## MITIGATED NEGATIVE DECLARATION

Project No. 630996  
SCH No. 2020110047

**SUBJECT: WATER AND STORM WATER GROUP JOB 968: A SITE DEVELOPMENT PERMIT (SDP)**  
The proposed project is to replace, rehabilitate, construct, and abandon several existing water mains and replace a storm drain. Work includes the installation of about 7,839 linear feet of 8", 12", and 16" water mains, 193 linear feet of storm drain, as well as abandonment of 7,382 linear feet of 6", 8", and 12" water main. Appurtenances include cutoff walls, fire service connections and hydrants, and curb inlets. Cast iron and asbestos cement water main will be replaced with PVC pipe, and storm drain will be replaced with rolled concrete pipe. Abandonment will occur in place. The proposed project includes a total of eleven sites. Six of the sites are in urban areas primarily within developed right of way, in the communities of Old Town, North Park, City Heights, Encanto, and San Diego Airport Authority property. In addition, five sites in the communities of Peninsula, Mission Valley, and City Heights propose work adjacent to and within Environmentally Sensitive Lands. The project sites are located within City Council Distr

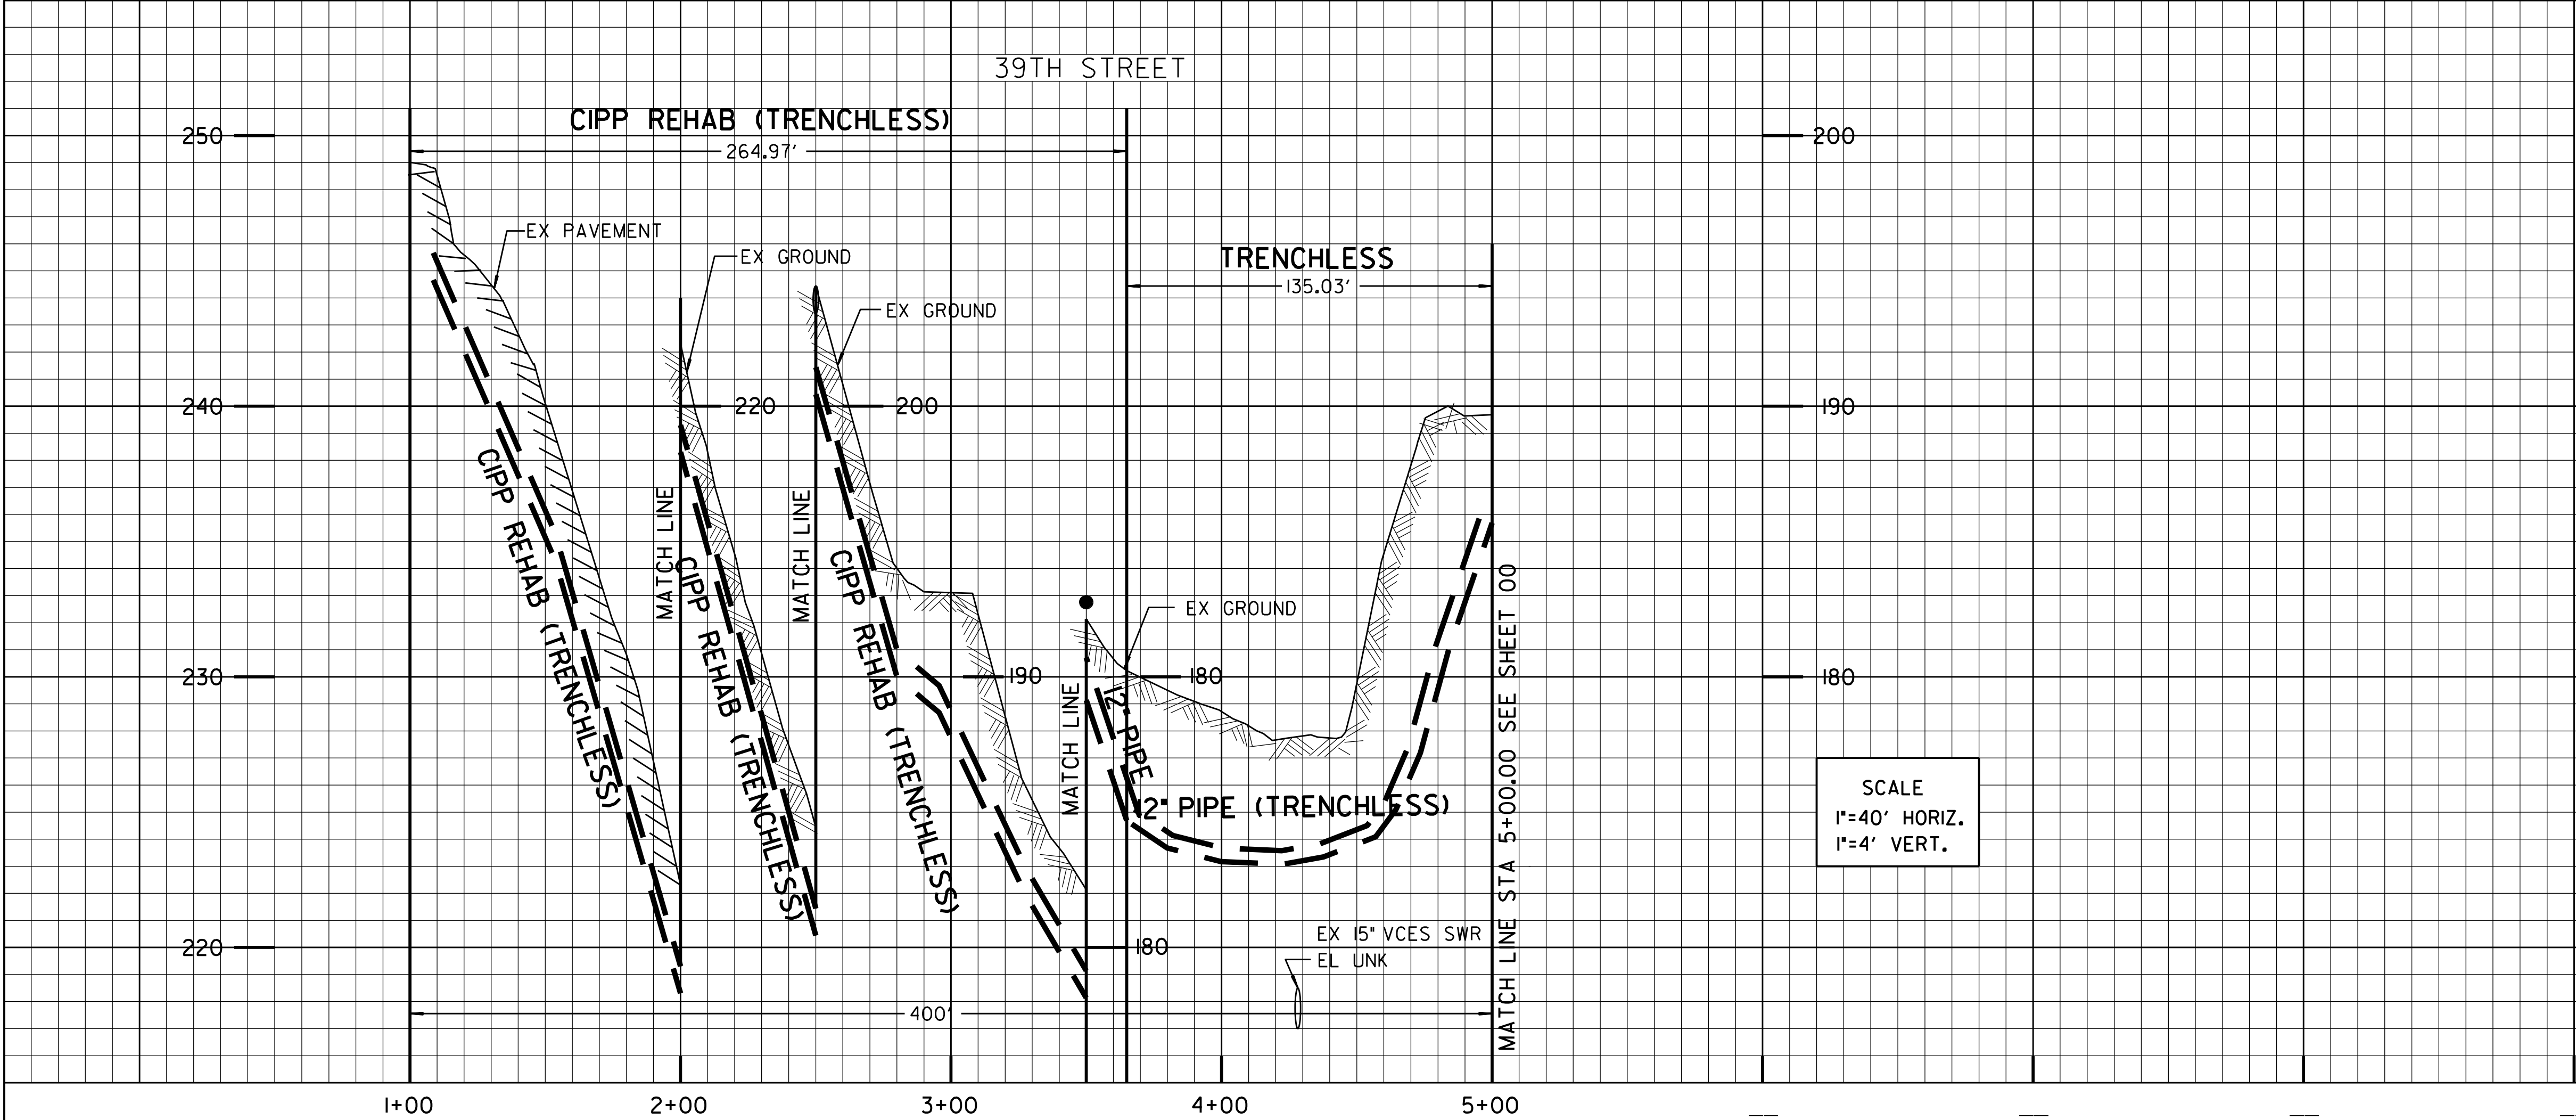
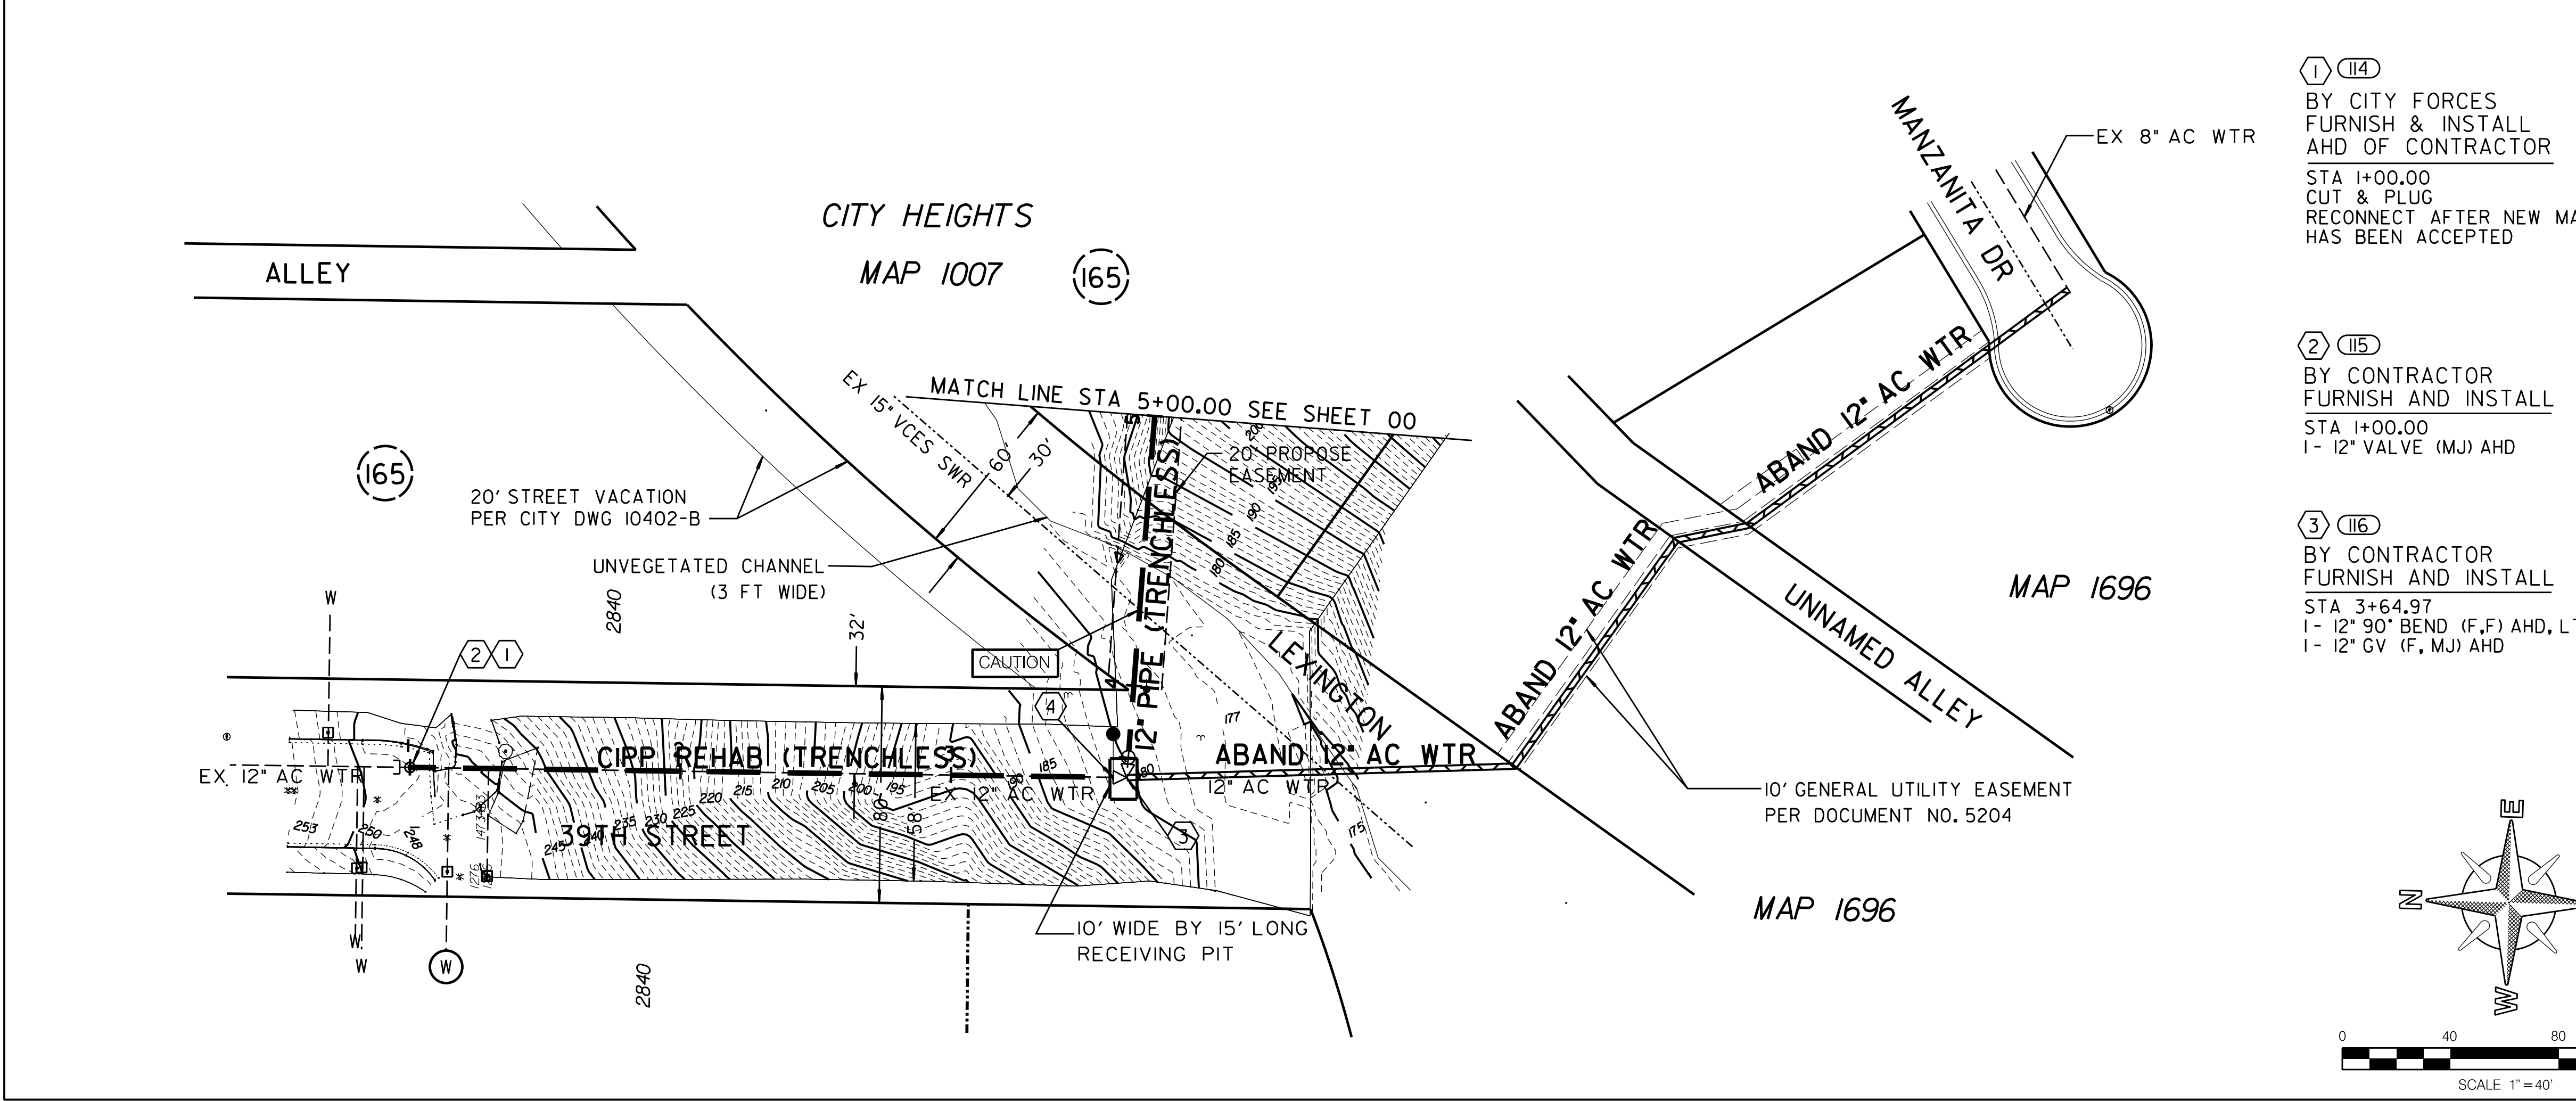
- COMMENT #1: Potential subsurface stream impacts from trenchless drilling and upland receiving pit impacts**
- A-5 **Issue:** The BRL mentions the water main underneath the stream in Site 12 would be replaced by trenchless drilling and refers to this as "aqua pipe." There is no description within the BRL, MND or the Preliminary Geotechnical Investigation (PGI) as to what "aqua pipe" is. The PGI mentions that waterline installation at Site 12 will vary from 2.5 to 4.5 feet below ground surface. There is no discussion if this depth is measured from the top of the pipe or the bottom. At the terminus of the trenchless drilling, there is also a temporary 10-foot by 15-foot receiving pit proposed within Diegan coastal sage scrub. In looking at Figure 3E in the BRL, it appears the receiving pit is approximately 70-feet up-slope from the stream. The stream within the Project footprint is seasonal and unvegetated, with a cobble bottom and vertical banks. There are signs of scouring and wracking.

**Specific impact:** One impact would be the alteration of subsurface water flow through the stream, impacting future seasonal surface flow on-site and downstream. Another impact would be the release of chemicals into the groundwater from frack-outs. This could potentially have downstream impacts to plants and wildlife as groundwater appears on the surface. The PGI mentions a shallow pipe depth (ranging from 2.5 feet to 4.5 feet) underneath the stream and an impact from a pipe not buried deep enough could be exposure of the pipe from scouring, possibly leading to impediment of flow.

**Recommendation Measure #1:** CDFW recommends the MND provide more information about the type of trenchless drilling being performed underneath the stream, the depth of the pipe under the stream, the distance from the stream of the receiving pit and how it will be created, and how frack-out will be avoided depending on the type of trenchless drilling method being used. CDFW recommends a scour analysis be performed or the pipe be located under the stream below scour depth to avoid future exposure of the pipe.

A-5. Please reference plan sheets 27 and 28 for water main installation at Site 12. Installation shall be by cured in place pipe liner rehabilitation (CIPP) from about STA 1+00 to STA 4+30, by trenchless methods from about STA 4+30 to 6+45, and by conventional open trench methods from STA 6+45 to 8+70. These methods will involve 3 excavations; one at STA 1+00 within the City street approximately 5' by 5' to begin the CIPP rehab installation; a second at STA 4+30 within the canyon approximately 10' by 15' which shall serve as the end of the CIPP rehab and beginning of the trenchless operation; and a third shall serve as the terminus of the trenchless pipeline installation and beginning of the conventional open trench installation approximately 3' wide and running the length of the pipeline.

Regarding the trenchless installation under the stream, this method was chosen to minimize impacts to the stream and vegetation. The launching pit for the trenchless operation is about 70 to 80 feet upstream. The depth of the main varies (measured from the surface to the top of pipe) but may be seen in the profile of sheet 27 and 28. The City allows the contractor to select any of or a combination of the 4 approved methods for trenchless installation; jacking, tunneling, micro-tunneling or horizontal
